P96-097 - 1812 Main Avenue

- REQUEST:
- A. **Negative Declaration**
  - B. **Mitigation Monitoring Plan**
  - C. **Plan Review** to develop a two one story office/warehouse and vehicle storage buildings on 1.402 $\pm$  vacant acres in the Light Industrial (M-1SR) zone.

LOCATION: 1812 Main Avenue  
APN: 238-0012-022  
North Sacramento Community Plan Area  
Grant Joint Union School District & Robla Elementary  
Council District 2

Exhibit C-2  
SITE PLAN

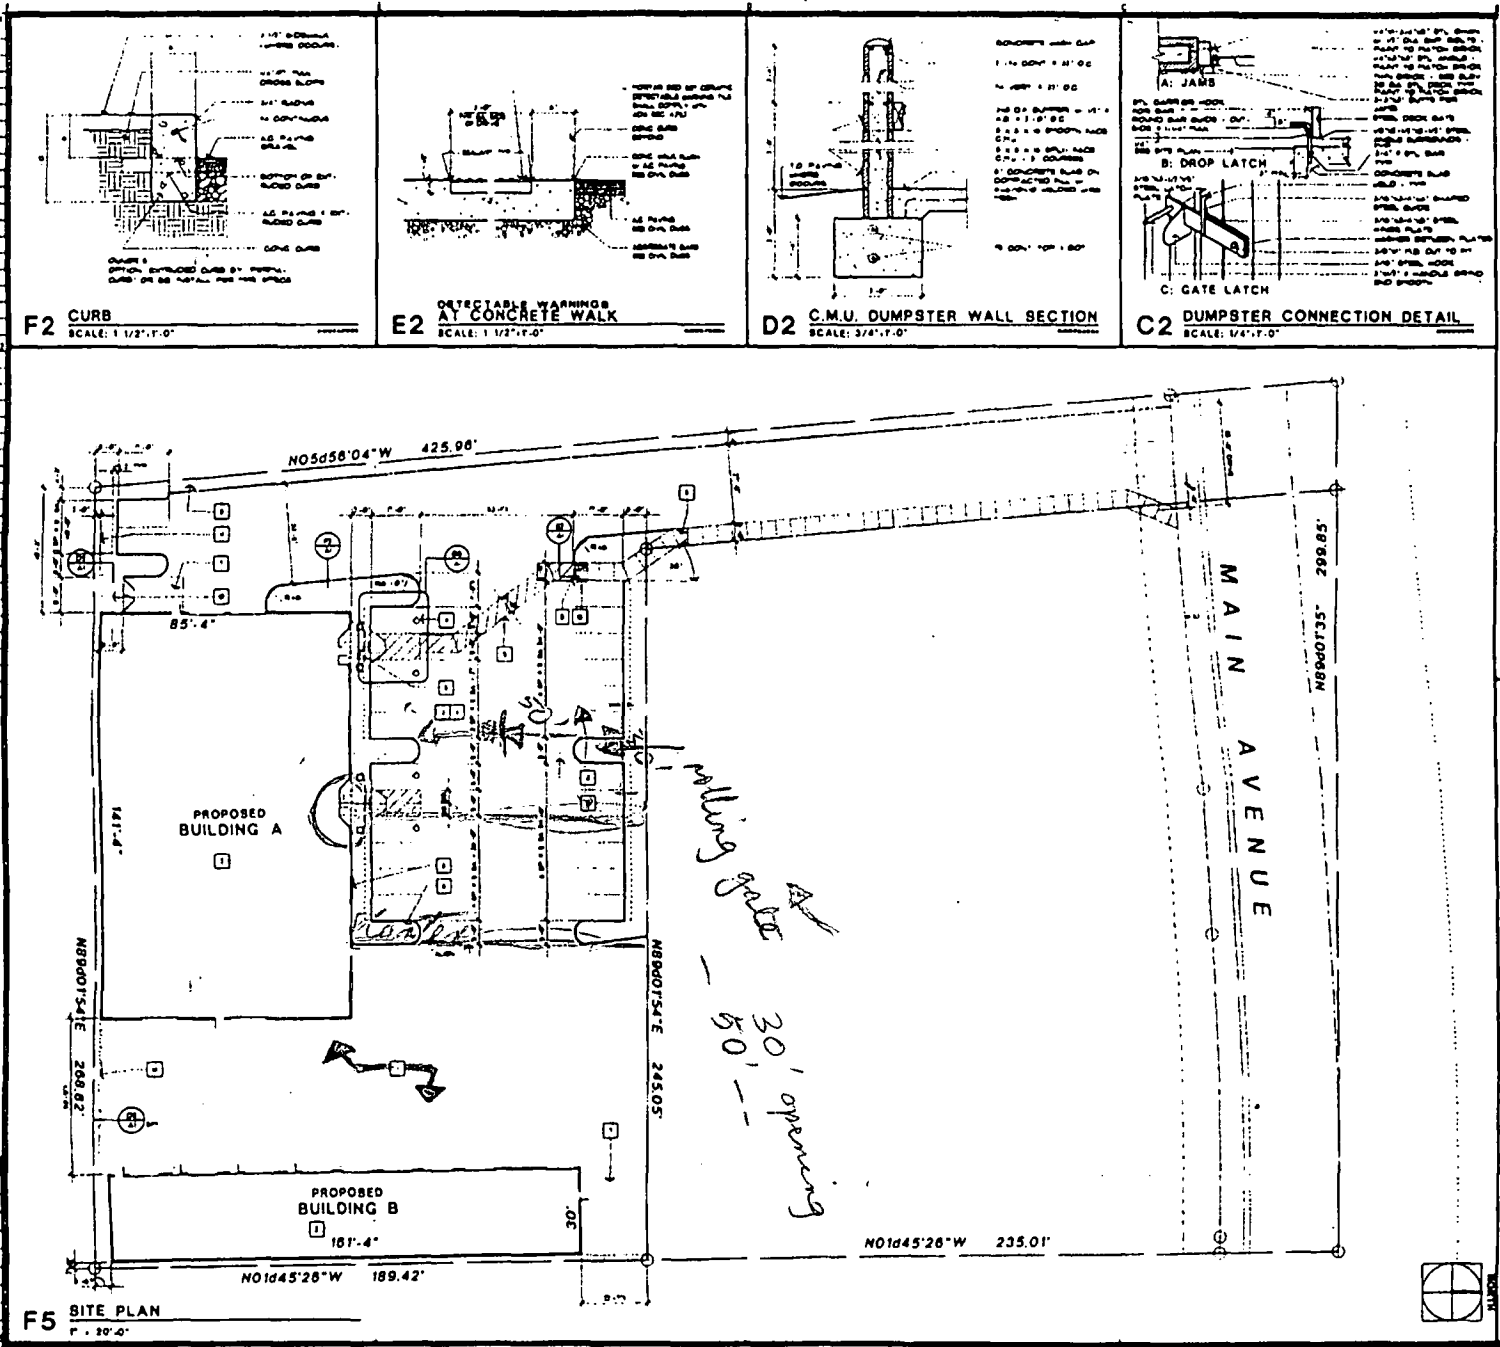
The M-1SR zoning requires a 25 foot building setback along Main Avenue. Adequate building and landscape setbacks are proposed. A chainlink fence is proposed to be located along the north property line adjacent to Parcel 2. The site plan shows the parking area fronting on the Building A and along the north property line. The vehicle storage building (Building B) is setback approximately 23' and 211' from the north property line and Main Avenue respectively and the office/warehouse building (Building A) is setback approximately 112' and 290' from the north property line and Main Avenue respectively.

As proposed on the site plan, both buildings abut the south and the east property lines. The building setback is only 2 feet. A six foot masonry wall shall be erected along the south property line because of the lot proposed for residential development on the southern parcel. The requirements from Building Division and the Fire Department are summarized below under Summary of Agency Comments.

The submitted plan also indicates a dumpster enclosure located west of building A along the south property line. The trash enclosure must meet all requirements of the zoning ordinance, including perimeter gate, masonry walls, and a solid metal gate. The location of the enclosure does not encroach into the designated parking and reciprocal driveway as shown on the site plan.

No bicycle parking spaces are shown on the site plan. The zoning ordinance requires one bicycle parking facility for every 25 off-street parking spaces provided for industrial uses. Staff would recommend that a minimum of one bicycle parking facility be provided on site.

A driveway for ingress and egress is located on the western boundary off of Main Avenue. The site will share the driveway with proposed development on the northernmost parcel fronting Main Avenue. Should development of the project site not meet City standards as per the Zoning Ordinance or the City Code, additional entitlements will need to be requested by the applicant.

Because the buildings are less than five feet from the south and east property lines, no openings (vents, windows and doors) are permitted on the walls abutting the south and east property boundaries. The bricks required for construction are the one-hour fire rated type.

Exhibit C-3  
ELEVATIONS - BLDG. A

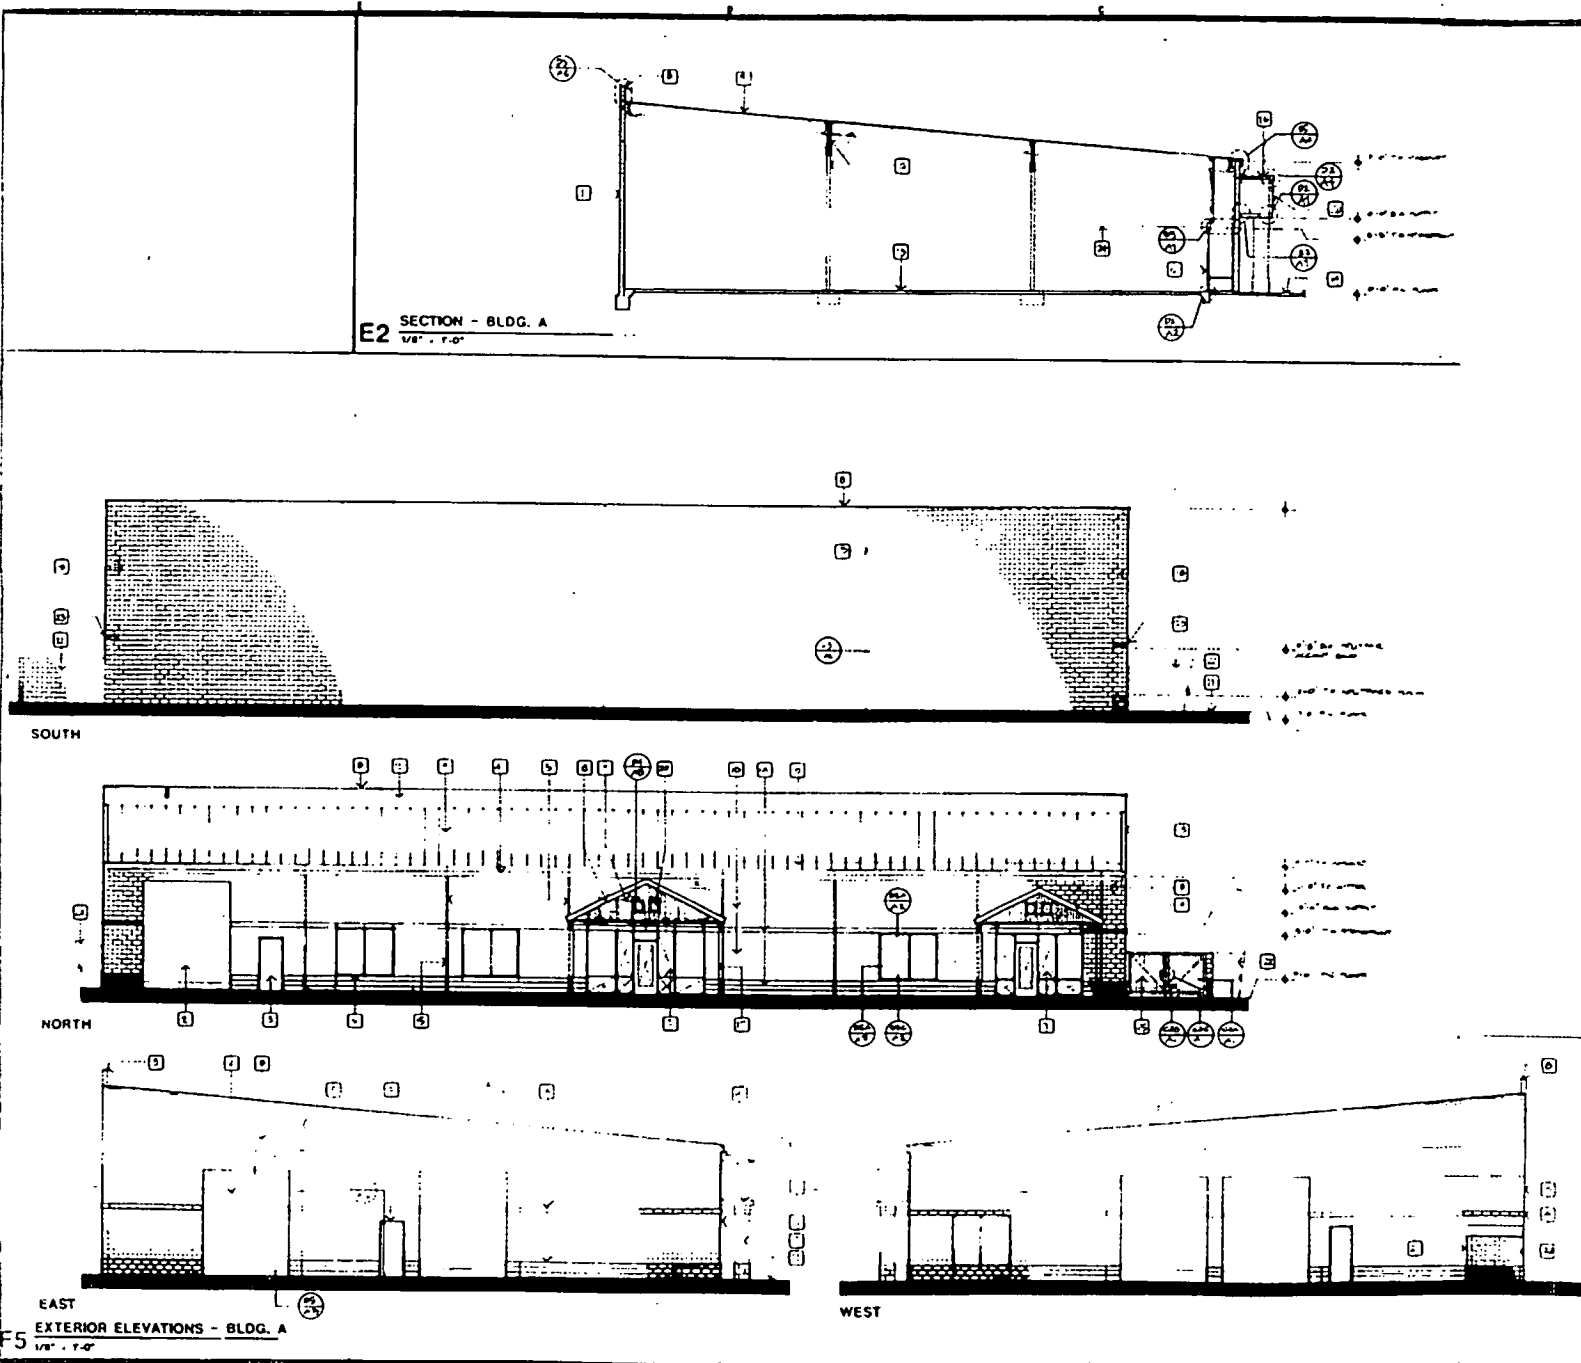
The applicant proposes to construct 28' and 23' high buildings respectively, 12,060sq.ft. office/warehouse and 4,080sq.ft. vehicle storage concrete block, glass and storefront buildings, with pre-finished metal roofing. The proposed exterior building colors are medium warm grays, blue roofing and solar grey glazing.

It is recommended that all mechanical equipment be placed behind the parapet wall to not be visible from the Main Avenue. Staff finds the building design compatible with the surrounding area and will enhance the area.
